SUBJECT: DRAFT SAFETY EVALUATION FOR BABCOCK & WILCOX MPOWER
TOPICAL REPORT R0003-08-002089, REVISION 3, "INSTRUMENT
SETPOINT METHODOLOGY TOPICAL REPORT" (TAC NO. RN6113)

DRAFT SAFETY EVALUATION REPORT FOR BABCOCK & WILCOX COMPANY TOPICAL
REPORT R0003-08-002089, REVISION 3, "INSTRUMENT SETPOINT
METHODOLOGY TOPICAL REPORT" (TAC NO. RN6113)
PROJECT NO. 0776

Figure 5.1: Setpoint Relationships – For Increasing Setpoint (Similar for decreasing setpoint, but process is decreasing towards the setpoint).

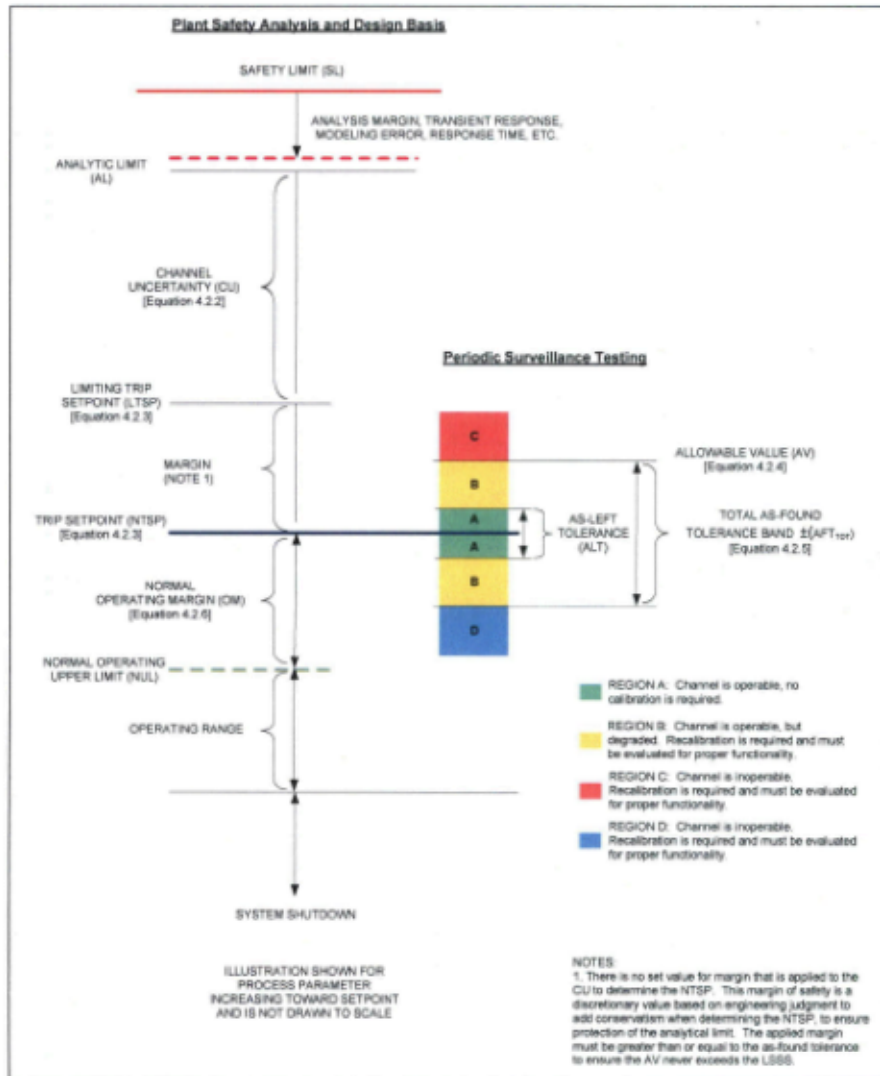
In the B&W methodology, the AL is established to ensure that a trip occurs before the SL is reached. The purpose of an LSSS is to assure that a protective action is initiated before the process conditions reach the AL. Trip setpoints are chosen based on the LSSS and to minimize spurious trips close to the normal operating point of the process. Figure 5.1 of the TR shown below provides a pictorial of the B&W setpoint methodology relationships.

As presented in the B&W setpoint methodology Sections 4.1.5 and 4.2.3, the applicant defines LTSP as an LSSS and also defines NTSP as the desired value of the measured variable at which an actuation occurs. The calculation of the LTSP value is set forth in Section 4.2.3 as $LTSP = AL \pm CU$, where CU is the total channel uncertainty. In Note 1 on Figure 5.1, the applicant defines AV such that it will never exceed the LTSP (LSSS) and in most cases should be more conservative than the LTSP. The calculation of the AV is set forth in Section 4.2.4 as $AV = NTSP \pm AFT_{TOT}$ where AFT_{TOT} is the total AFT for the entire instrument chain. The NTSP includes additional margin such that it is more conservative than the LTSP. In Section 4.2.5 the applicant defines the AFT and ALT as double sided bands around the NTSP. The applicant states that at a minimum the AFT includes reference accuracy, drift, and ALT

uncertainties. The ALT is based on accuracy of the channel calibration. The staff finds that this approach is consistent with RG 1.105, Revision 3 and ANSI/ISA-67.04.01-2000.

Based on the discussion, sample calculations, and figures presented in the TR, the staff finds that the B&W setpoint methodology demonstrates that the correct relationships between the SL, AL, AV, NTSP, LTSP, AFT, and ALT will be ensured, that the basis for the trip setpoint is correct, and that the requirements of GDC 13 and 20 are met.

NRC RIS 2006-17 detailed a concern with verification of operability using only AV or a one-sided approach during periodic testing (channel operational test, calibration test). To address this concern the B&W mPower setpoint methodology uses double-sided acceptance criteria bands. Figure 5.1 (above) and Table 4.2 (below) of the TR describe how the operability of the instrument loop is evaluated. Exceeding the AFT in either the high or low direction may indicate degraded performance and inability of the instrument channel to meet its intended function.
